Design Exception #5

Slopes at the MP 185 Cut Wall

I-70 West Vail Pass Safety and
Operations Improvements

I-70 WB Cut Wall Typical Section ~ MP 187.5
Wall at 25' From Ultimate Travelway

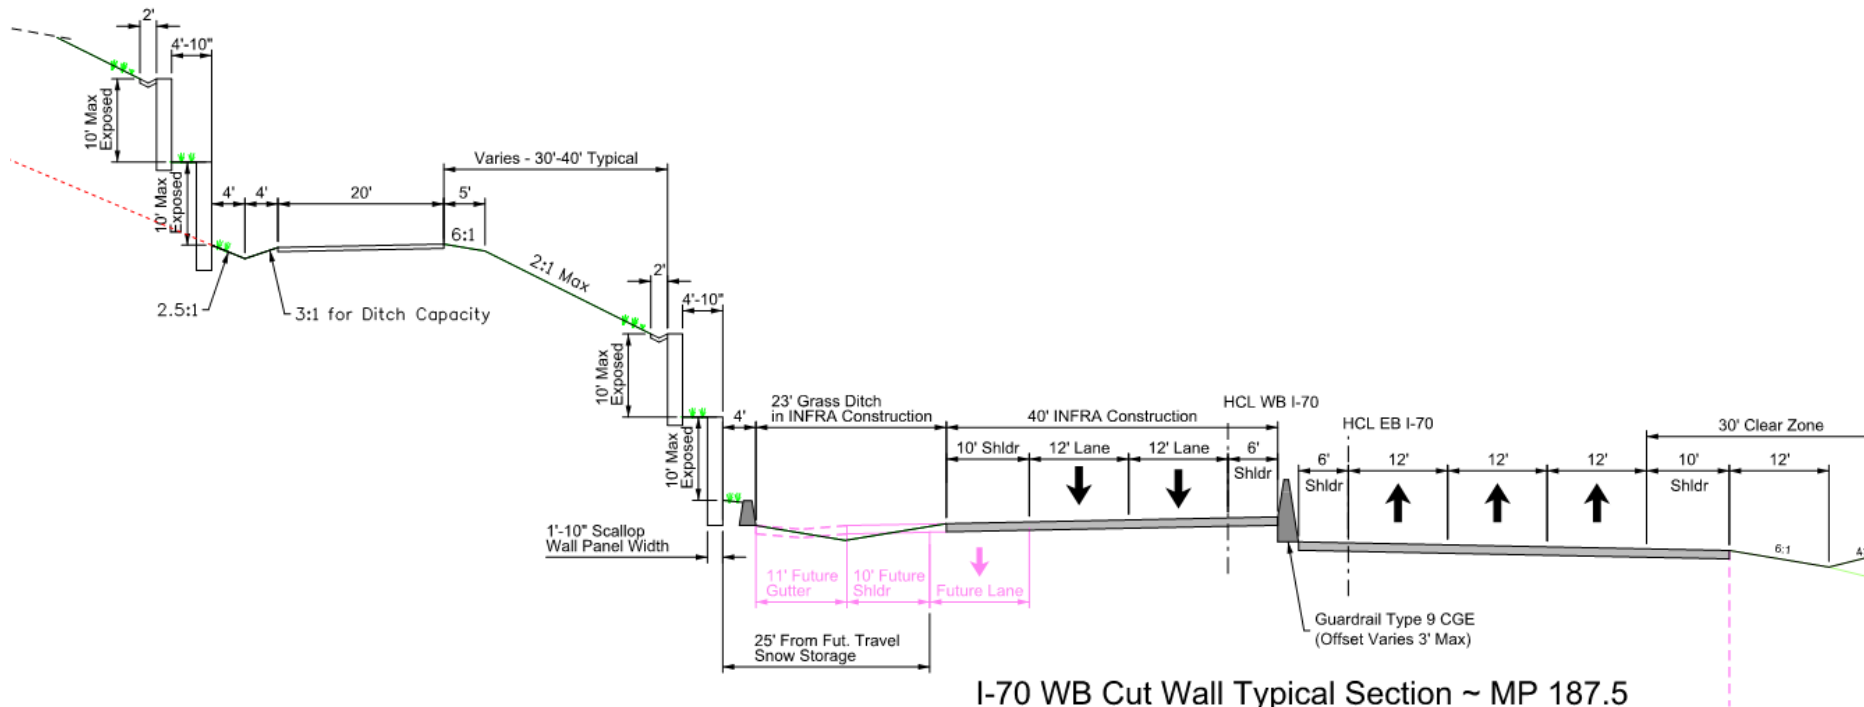
2. Greg said I know when we were talking about the roadway design and the bridges, you said the bridges were about 10' apart or parallel and then there was a space when you go to your section, it does not look like we have any kind of median.

3. Greg asked for clarification that the Design Exception is a grading exception, not a wall exception.

Brian said it is shown incorrectly. On the westbound side we have the 6' inside shoulder and there will be a little bit more of an offset. We are working through the details of whether we need to have barrier on eastbound and westbound individually or whether we can have that CD barrier in the middle. There will be just a little bit of an open median through this section. This will be updated to show further separation as there is actually 8-9' feet in there.

Brian confirmed a grading exception is what we are requesting. To reduce the walls, we would like to use the 2:1 slopes grading design exception.
